Addendum No. 03

May 8, 2024

Universal Transitional Kindergarten Lincoln Elementary School

PBK PROJECT NO.: 220486
DSA FILE NO.: 20-30
DSA APPLICATION NO.: 02-121587

DEMOLITION
PLAN

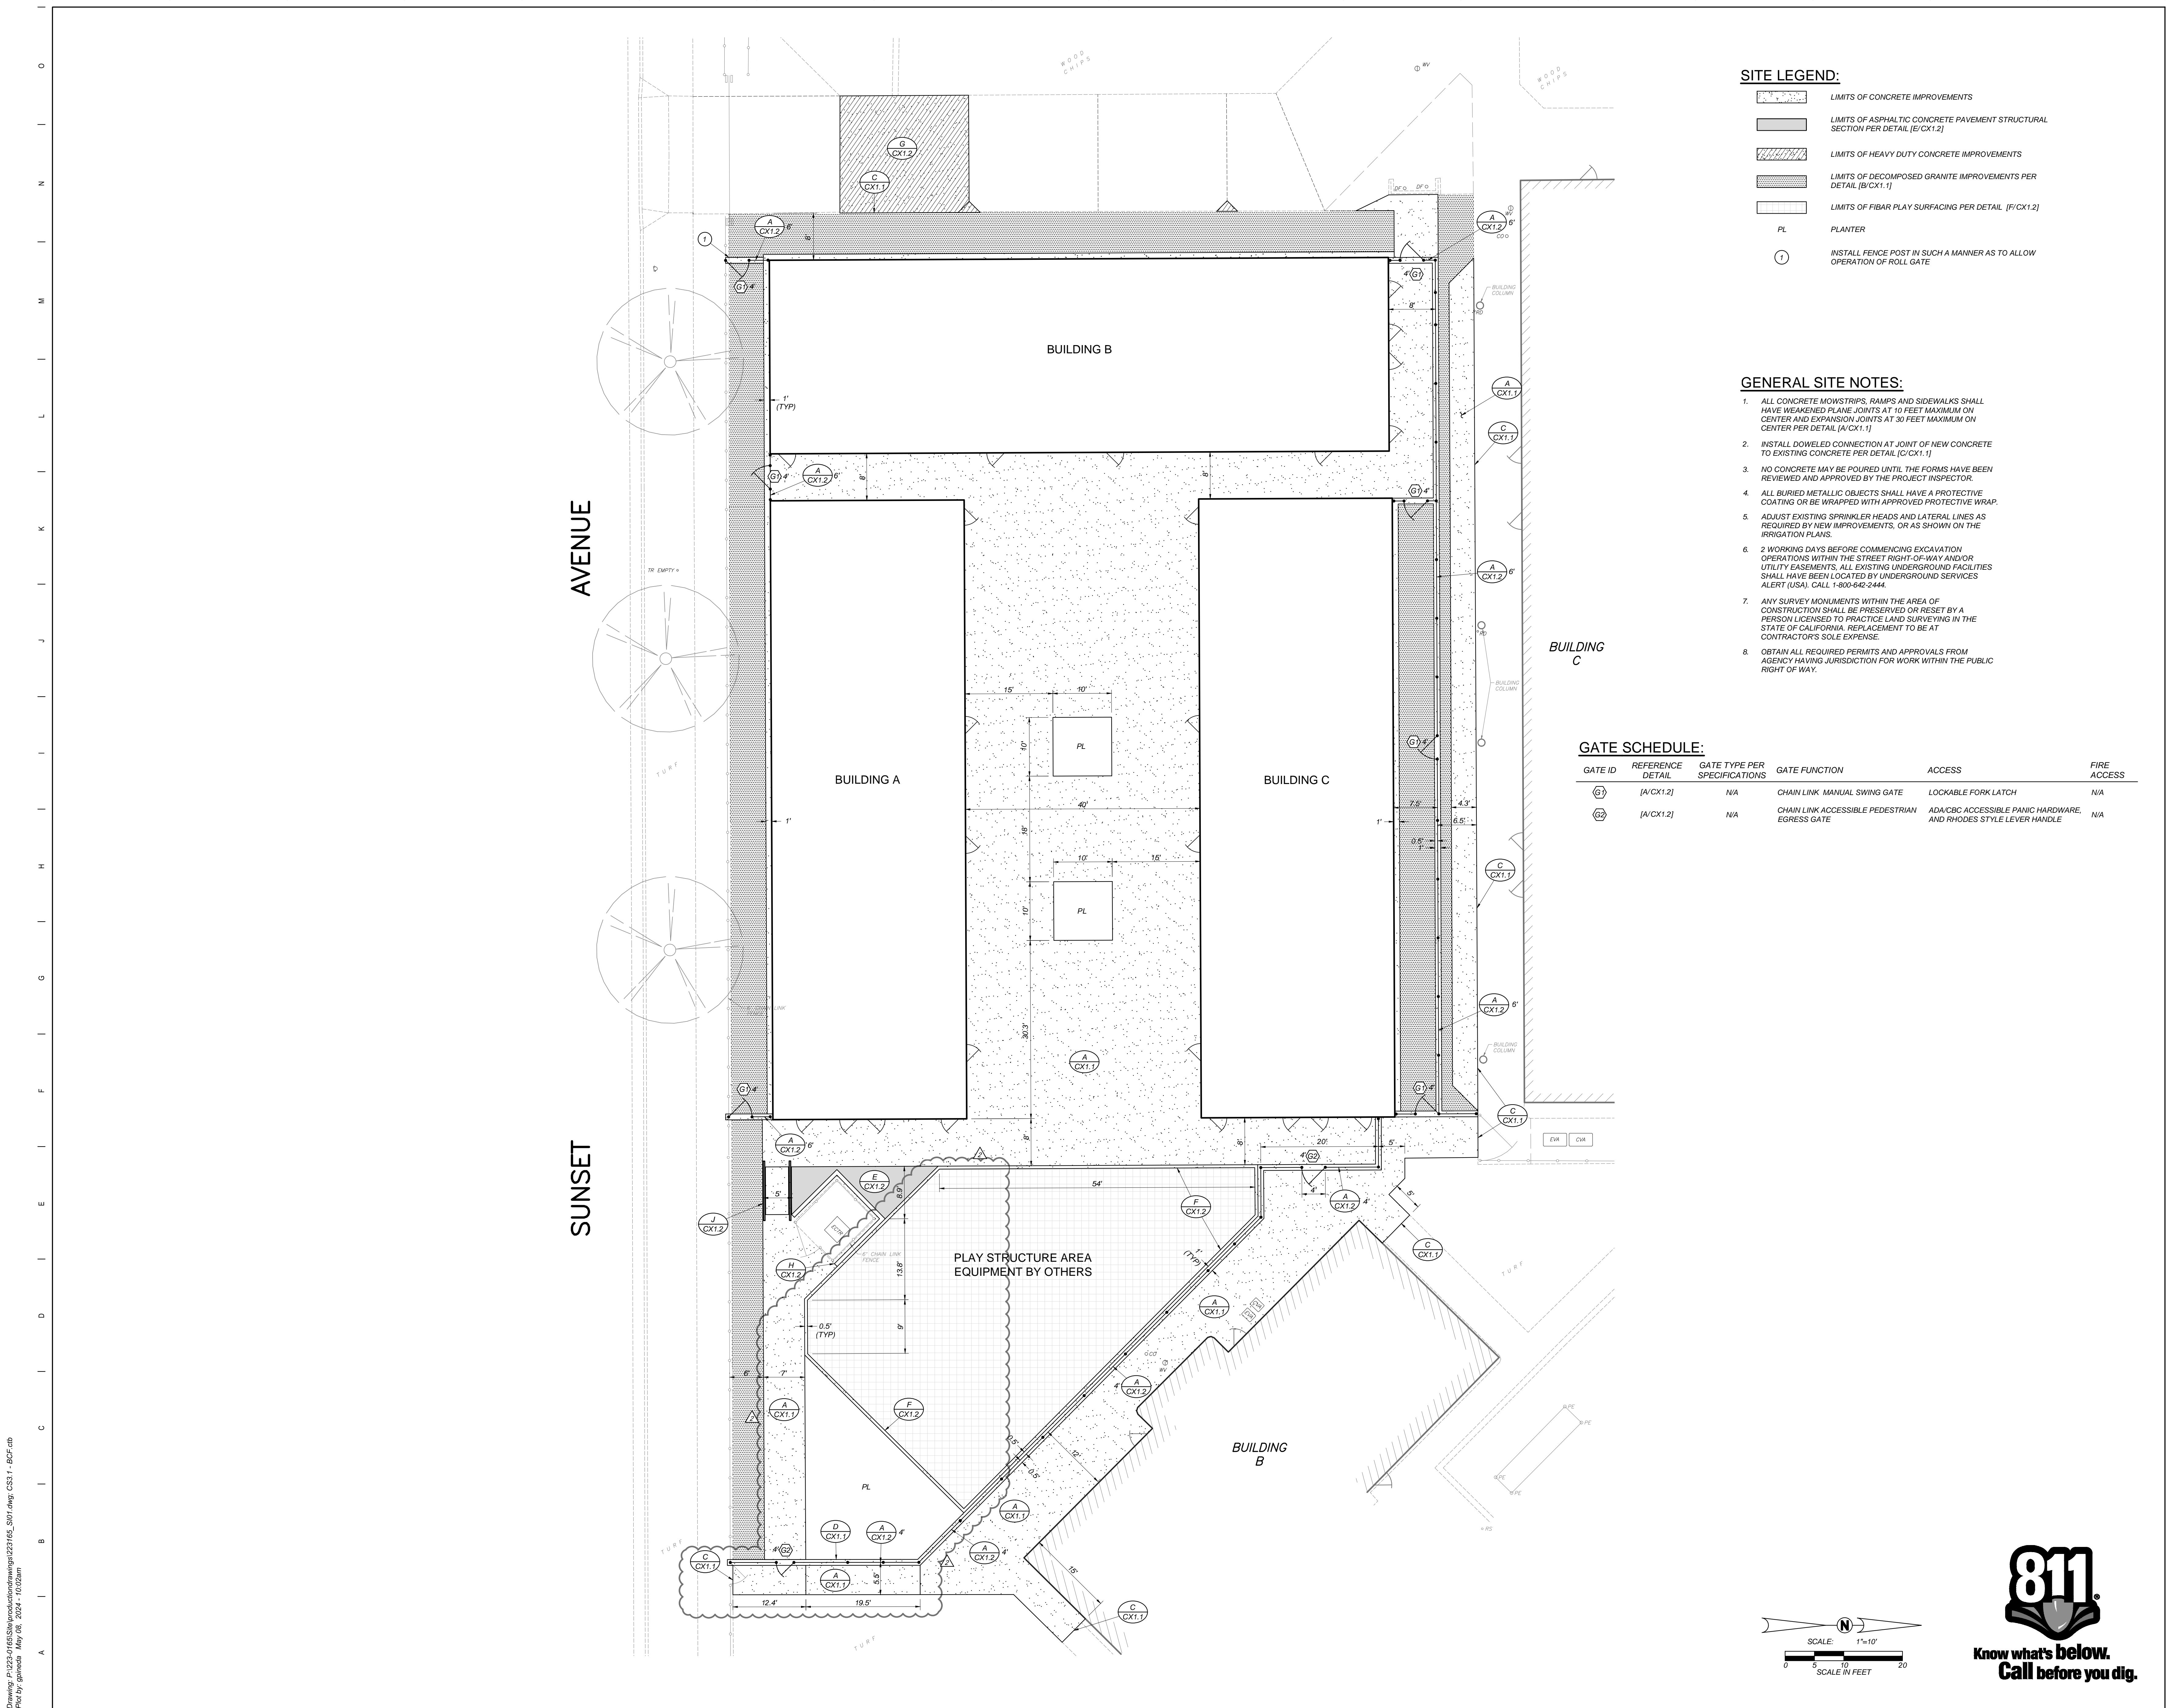
3-01 CS2.1 – DEMOLITION PLAN, revise as follows:

- a. Additional concrete removal and revisions have been clouded with delta 2. Remove and replace with attached drawing.

SITE PLAN

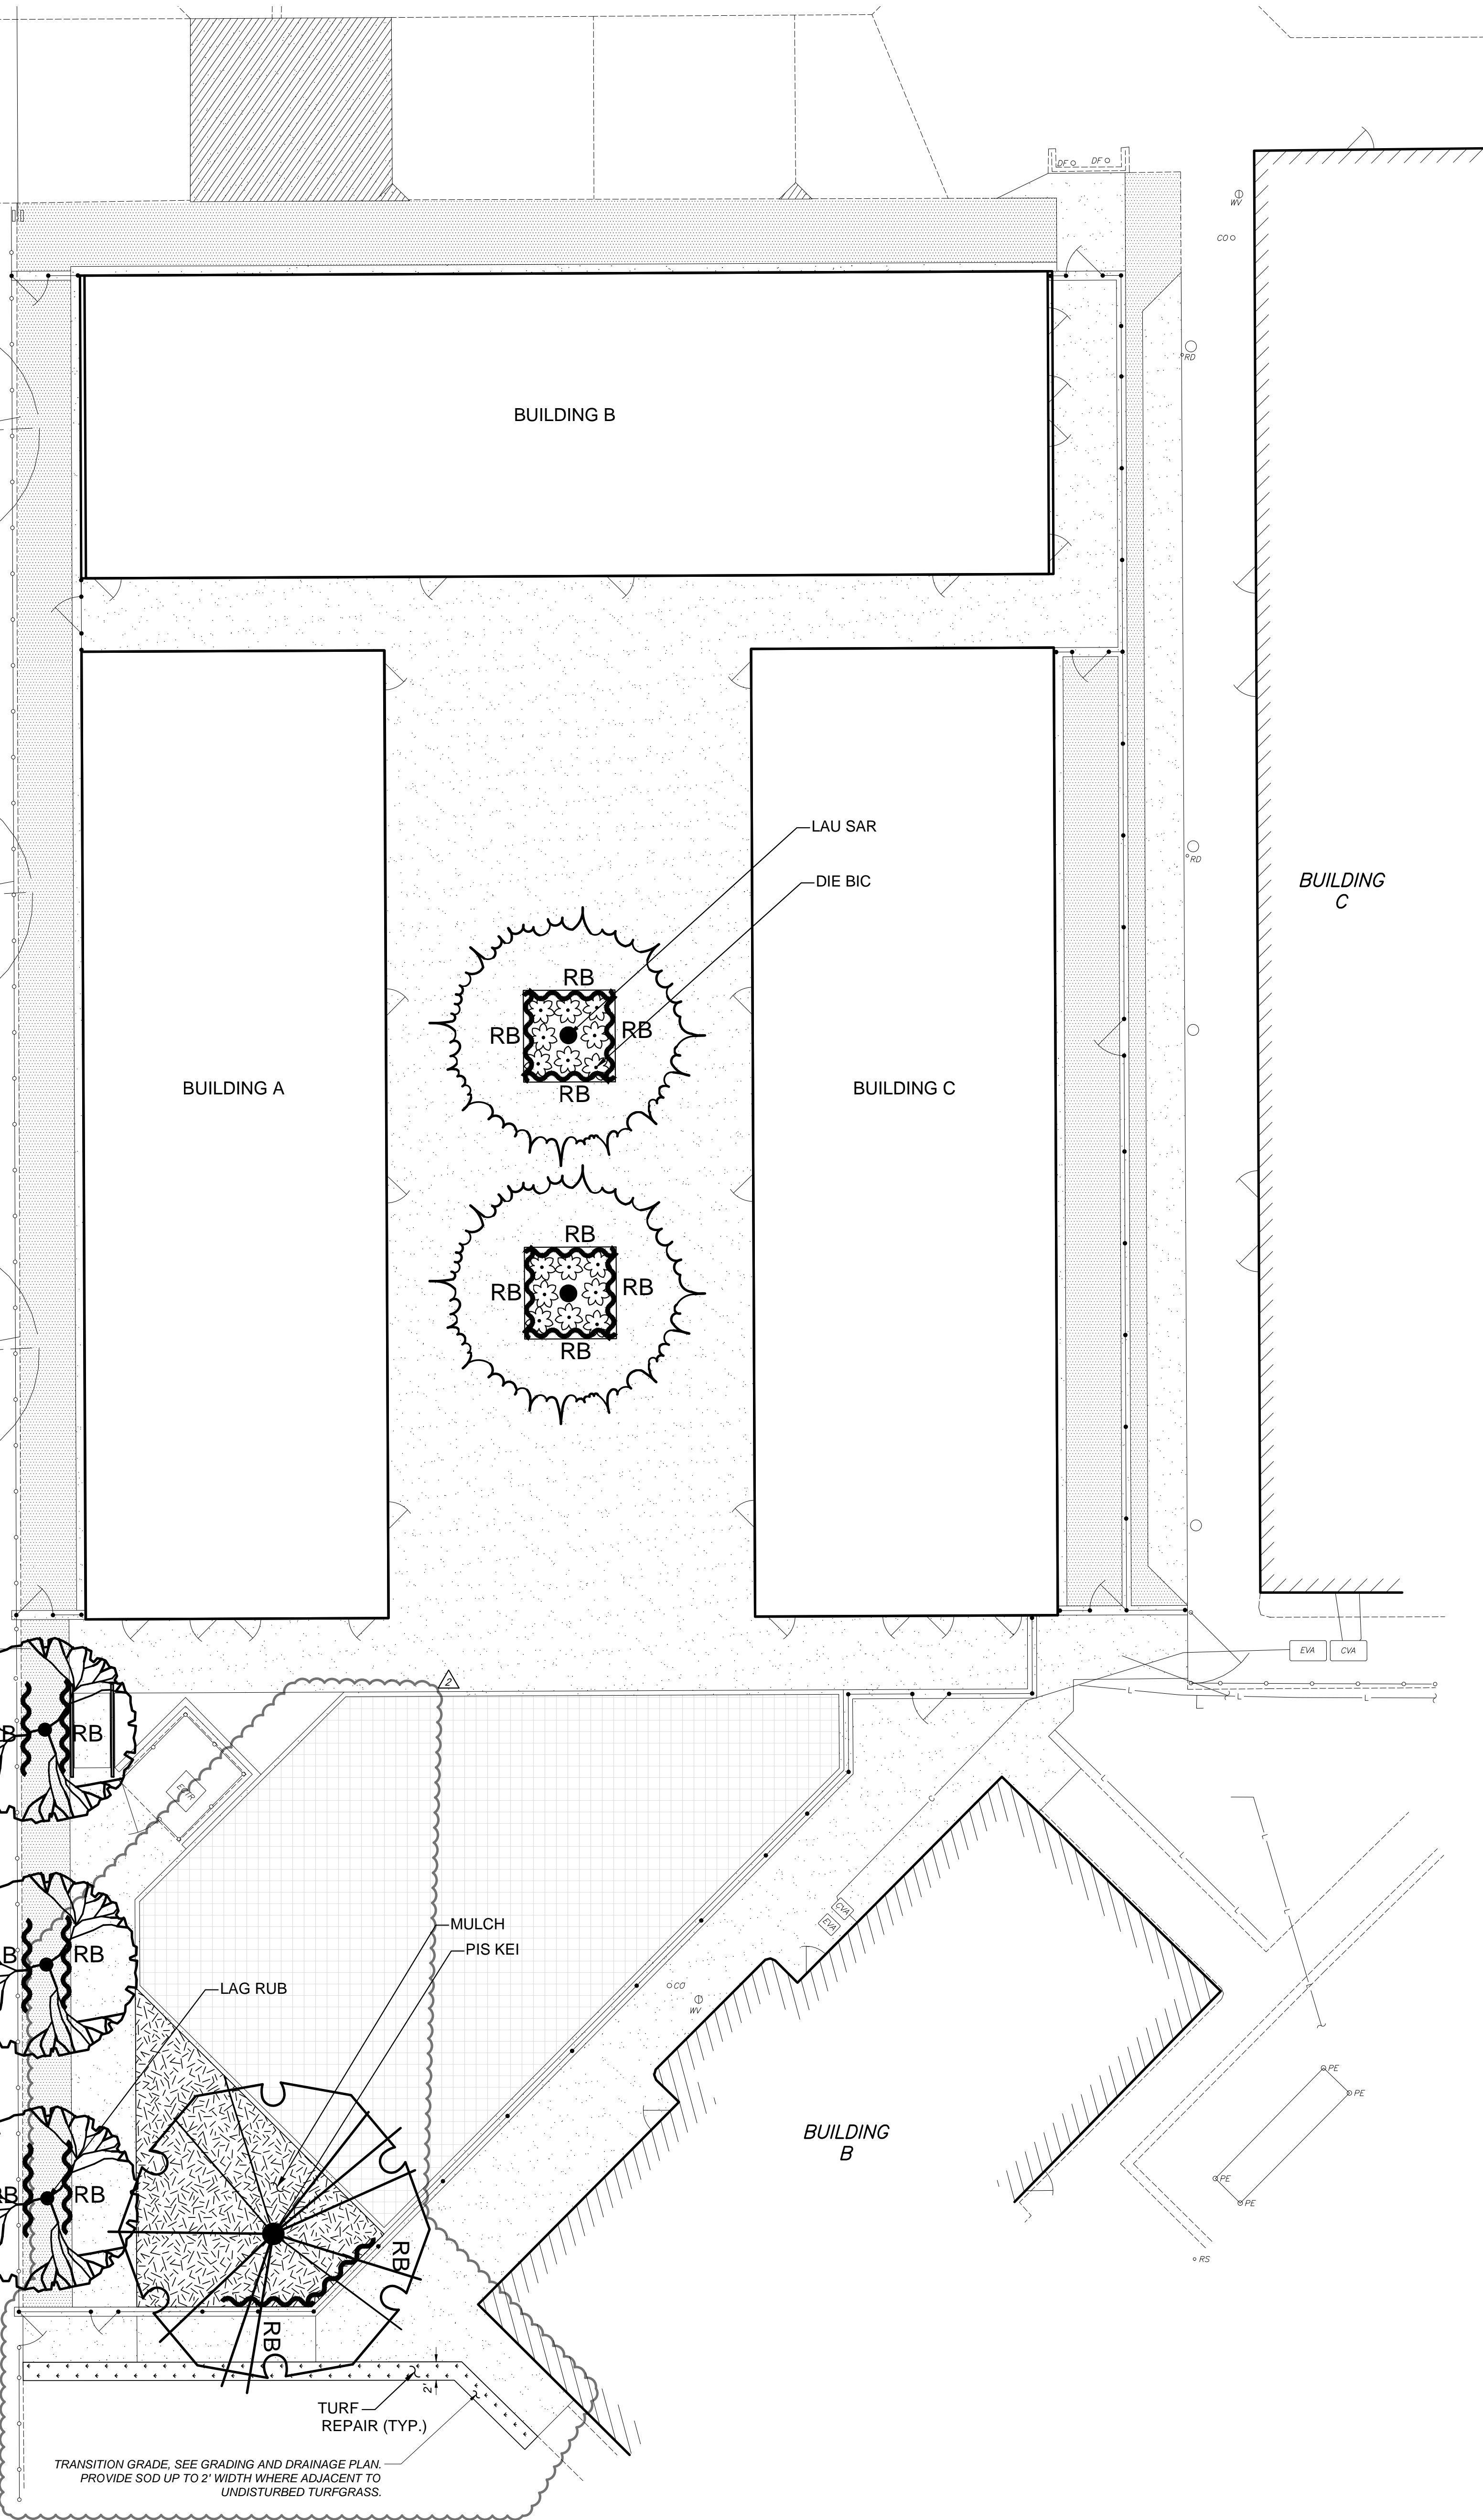
3-02 CS3.1 – SITE PLAN, revise as follows:

- a. Extension of play equipment areas; revisions have been clouded with delta 2. Remove and replace with attached drawing.
- b. Extension of sidewalks and addition of a pedestrian gate. Revisions have been clouded with delta 2. Remove and replace with attached drawing.
